MARK	DATE	DESCRIPTIONS	BY	CH'D	CCO#
0	06/22/11	OTD DIVIDER RAIL MODIFICATIONS	TH	JD	192

SAN FRANCISCO OAKLAND BAY BRIDGE
EAST SPAN SEISMIC SAFETY PROJECT

OAKLAND APPROACH STRUCTURES CLEANUP ITEMS

BIKEPATH RAILING DIVIDER

OAKLAND APPROACH STRUCTURES
RAILING DIVIDER DETAIL
1:5

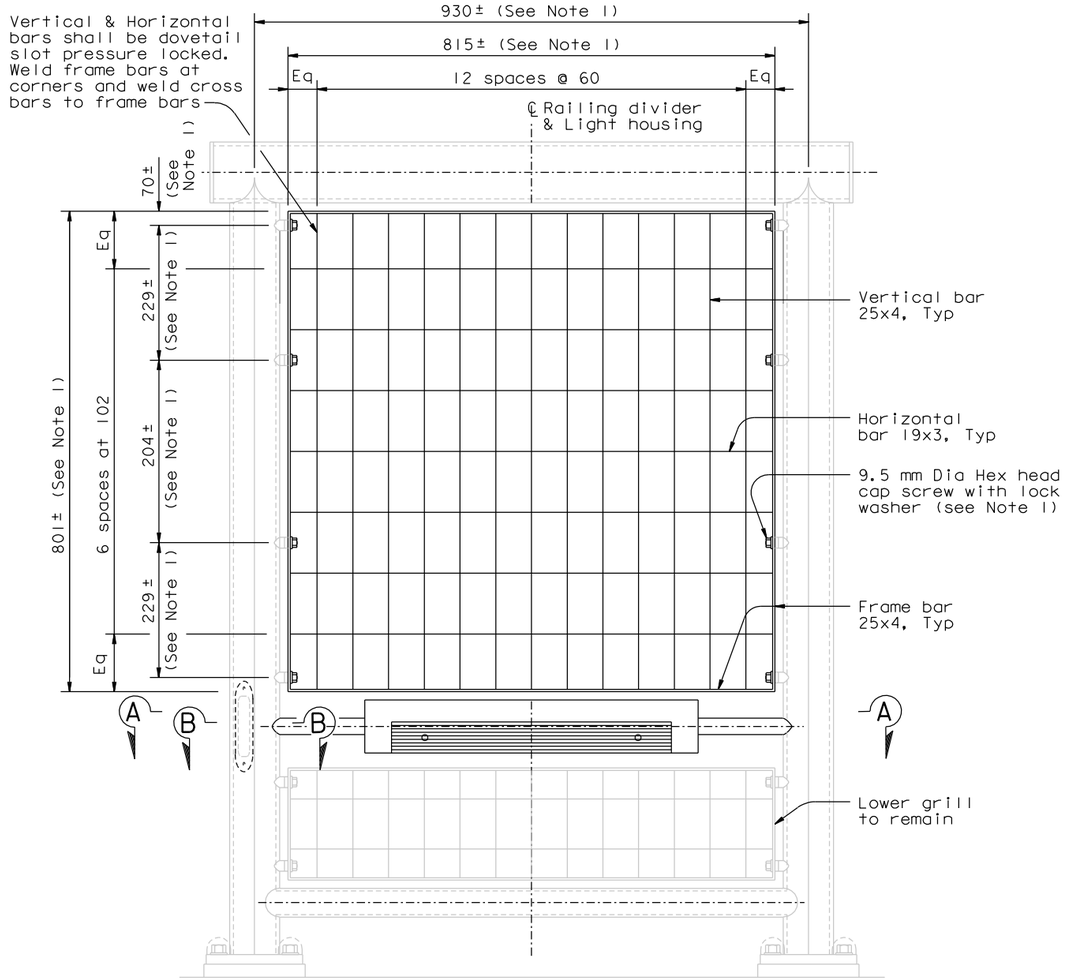
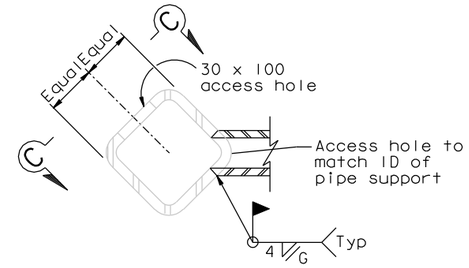
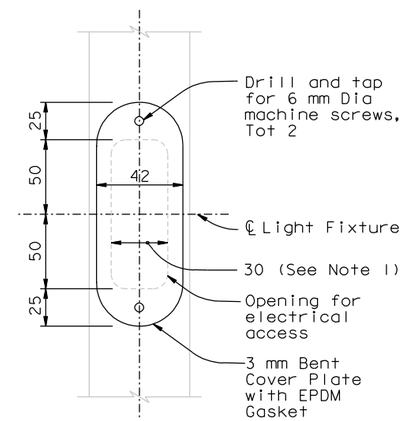
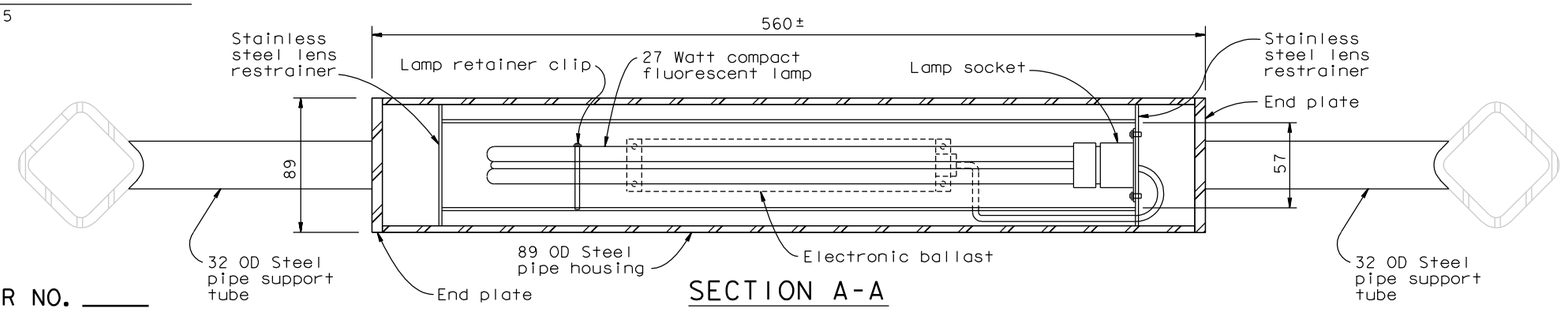
RAILING DIVIDER MODIFICATION PROCEDURE:

1. Remove and install new upper railing grill.
2. Remove and install new light housing.
3. Drill and tap holes, install new access hole cover plates.
4. Galvanized surfaces shall be repaired. Areas with damaged paint or with no paint shall be cleaned and painted.

HANDRAIL ADJUSTABILITY DETAILS

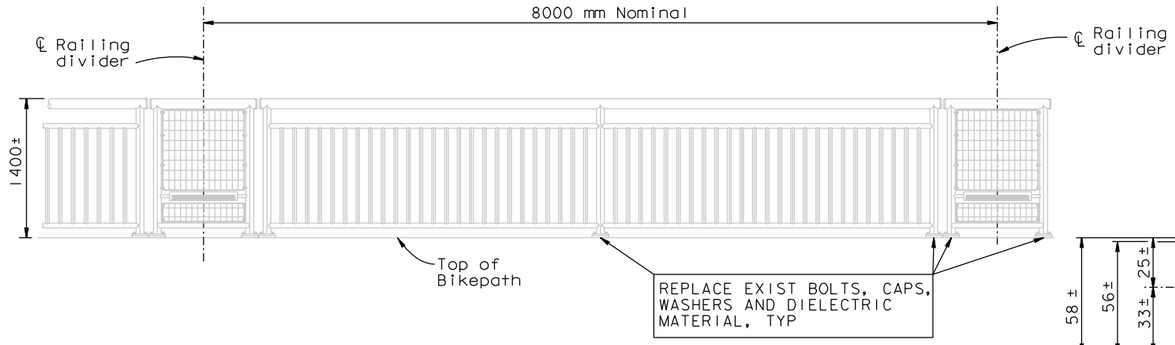
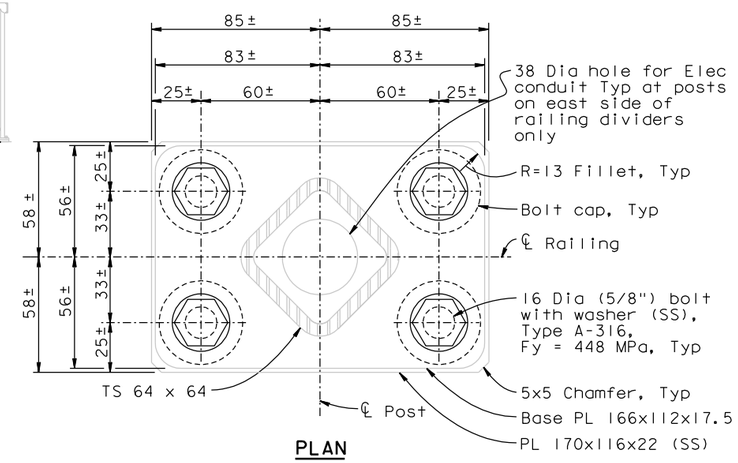
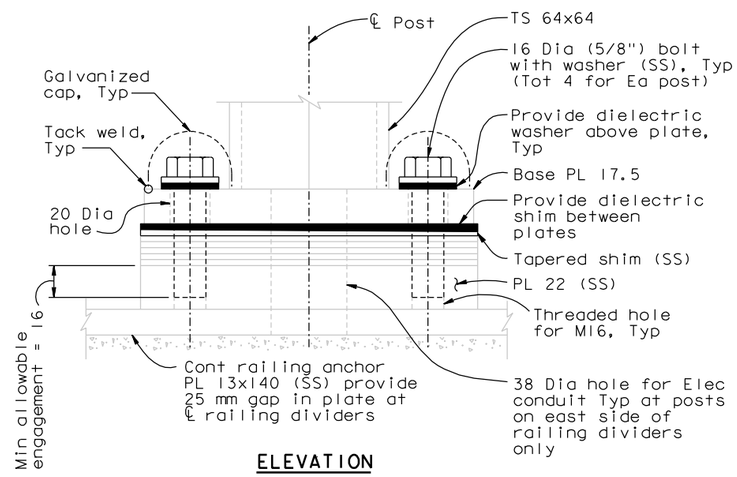
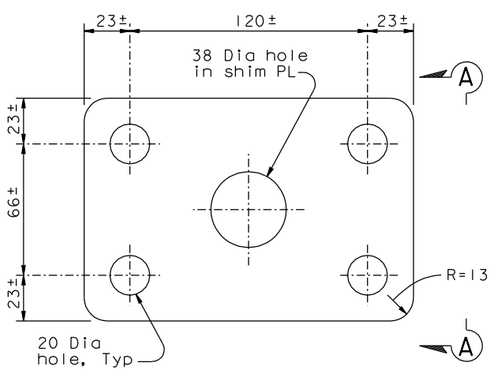
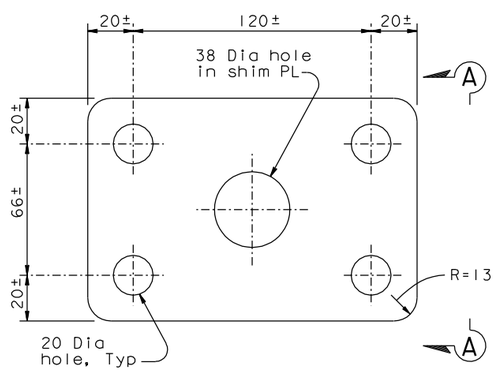
BOLT AND SHIM REPLACEMENT PROCEDURE:

1. Remove and discard bolt, cap and washer.
2. Remove and discard the dielectric material above and below the base plate.
3. Clean out and dry the threaded anchor hole.
4. If needed, replace the top most existing stainless steel standard shim with a new stainless steel tapered shim of thickness and taper necessary to properly align top rail of bikepath railing.
5. Install dielectric shim (UHMW) below base plate.
6. Install dielectric washer (UHMW) above base plate.
7. Insert new bolt, domed cap and washer. The length of the bolt shall be such that the engagement length into the PL 22 is a minimum of 16 mm.
8. Bolts shall be tightened to "Snug Tight Plus 1/4 Turn". Bolts shall be installed with thread locking compound.

MARK	DATE	DESCRIPTIONS	BY	CH'D	CCO#
0	08/26/11	OTD DIVIDER RAIL MODIFICATION	JD	TH	192
